CITY OF SAN ANTONIO
TRANSPORTATION & CAPITAL IMPROVEMENTS

ADDENDUM No. 2

PROJECT NAME: FIRE STATION # 2 REPLACEMENT, Project No. 20-00011

DATE: May 17, 2016

IT401A

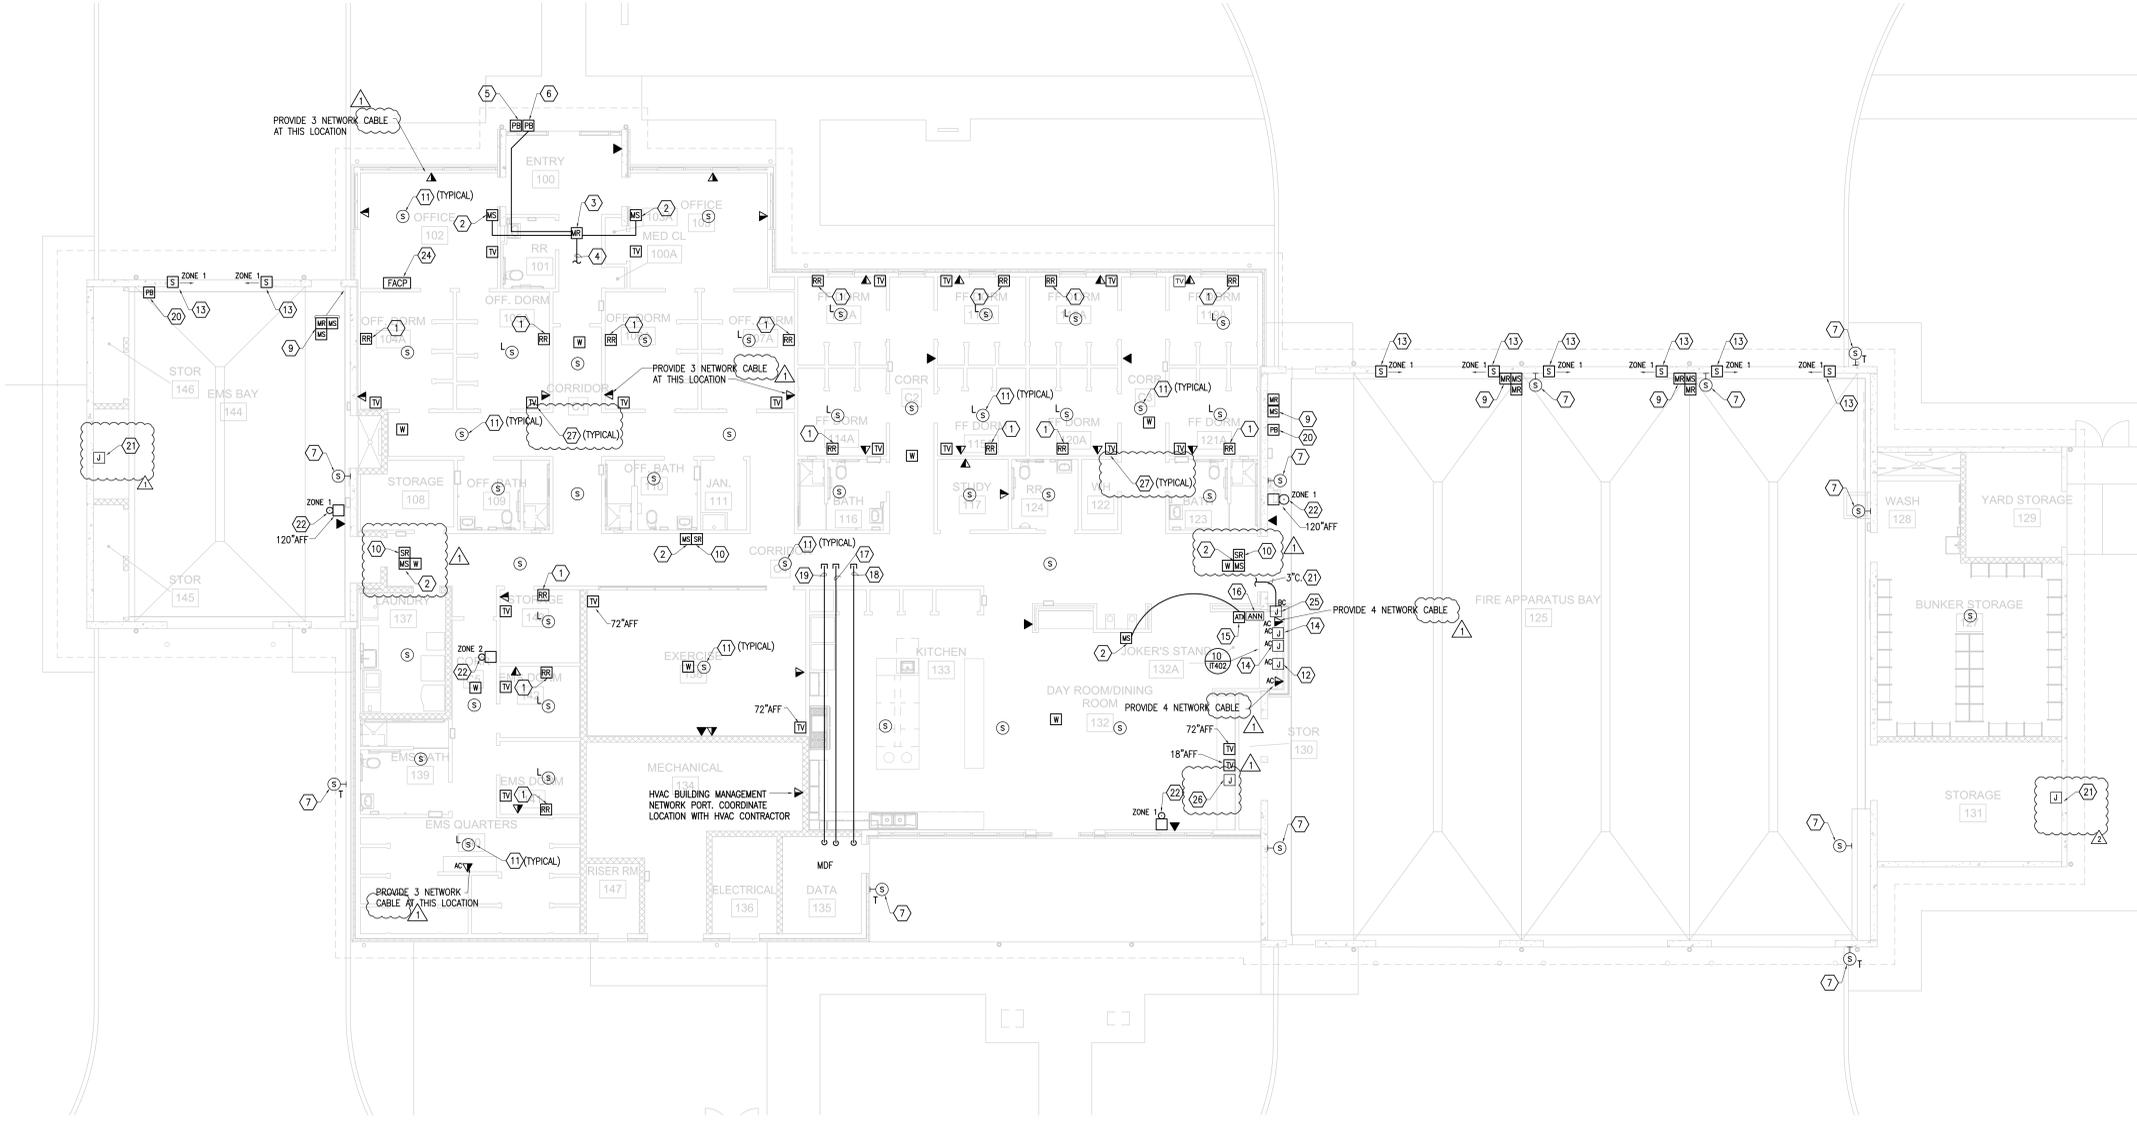
2. Replace Drawing Sheet IT401A
 - a. Added keyed notes 26 and 27.
 - b. Modified phone outlet description on legend to read as mounted at 48"aff.
 - c. Added j-boxes to antenna locations in the east and west end of the bldg.
 - d. Modified various notes for read as "cables" rather than "drops".
 - e. Added a j-box in the dayroom for an av-in location.
 - f. Relocated mud ring devices.
 - g. Modified key note no. 9 to read as the sign mounted at 9'-0".
 - h Added key note to drawing for typical TV outlets as being 12" to 18" from wall.

Sheet Title
 DOMESTIC WATER & GAS PLUMBING -
 BASE FLOOR PLAN

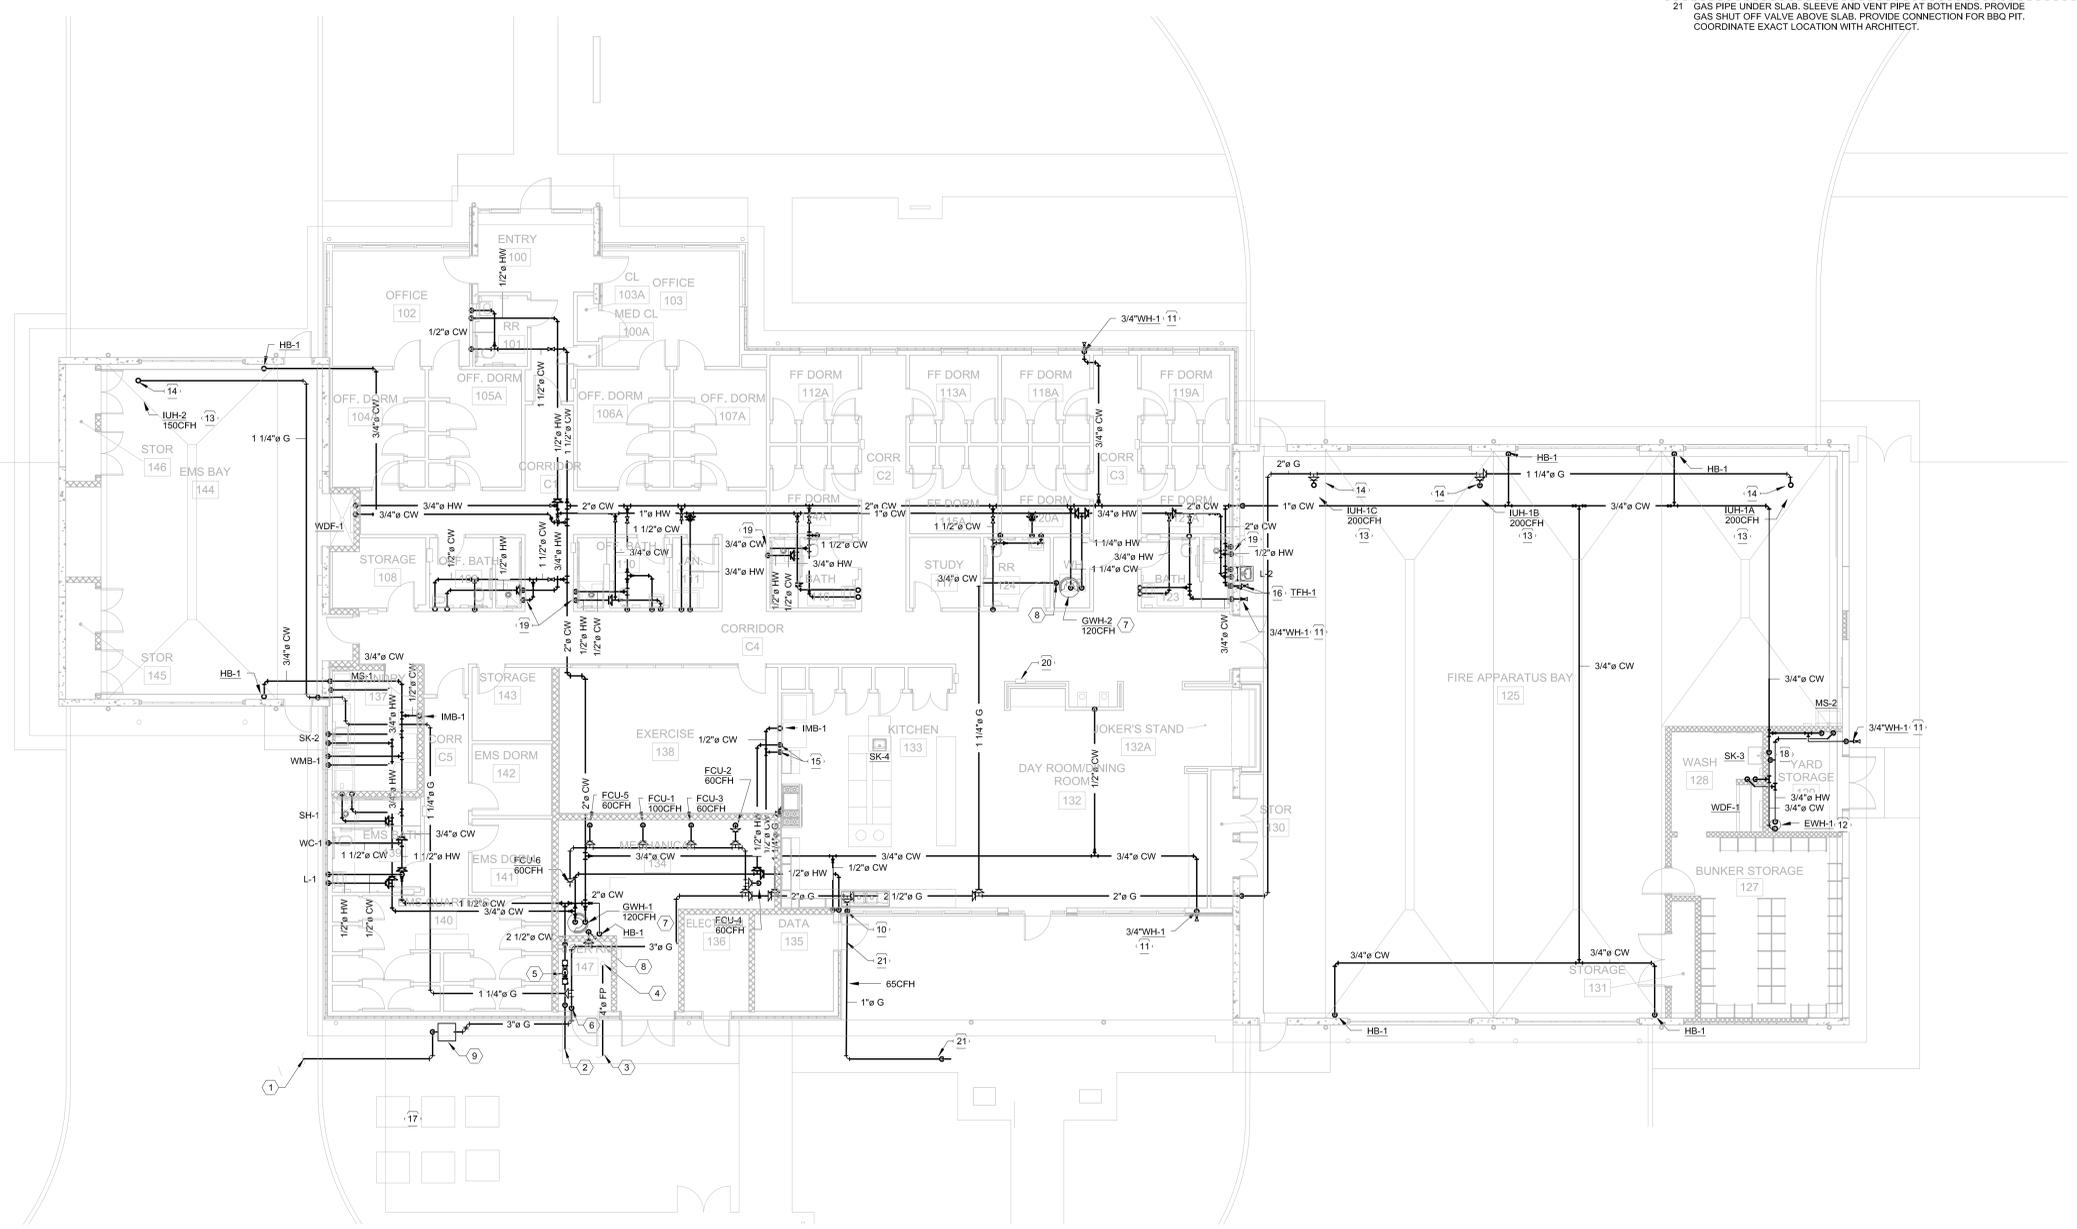
1. Replace Drawing Sheet P102
 - a. Revised plumbing keyed note #20 to specify the ASCO Relay and Gas Valve Control Panel Model 108D90C.
2. Replace Drawing Sheet P102A
 - a. Revised plumbing keyed note #20 to specify the ASCO Relay and Gas Valve Control Panel Model 108D90C.
3. Replace Drawing Sheet P202
 - a. Revised the Plumbing Fixture Schedule for L-2 to reflect the removal of the foot pedal accessory.
 - b. Revised the Plumbing Fixture Schedule for TFH-1 to reflect the addition of the Watts Series LF007 backflow preventer.
